Carburetor Sediment Bowl Breaks When Removed

Product: Greensmaster® Walk Mowers

Please contact your Toro Commercial Products Distributor for assistance with this issue. Please reference Commercial Service Bulletin Greens Reels 05-12 when making your inquiry.

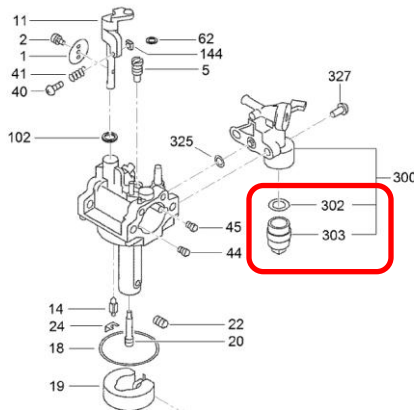
Removing the fuel sediment bowl can result in fracture of that plastic component. (Item 303)

The engine manufacturer is evaluating the issue and modifications are pending. As an interim resolution, it is recommended to use a 12 point 17 mm socket to remove the cup for inspect and maintenance process. Tightening method: Temporarily (hand) tighten for 2 to 3 rotations, then tighten by low range torque wrench. The torque spec is: 15.9 in/lbf ± 2.65 in/lbf (1.8 Nm +/- 0.3 Nm)
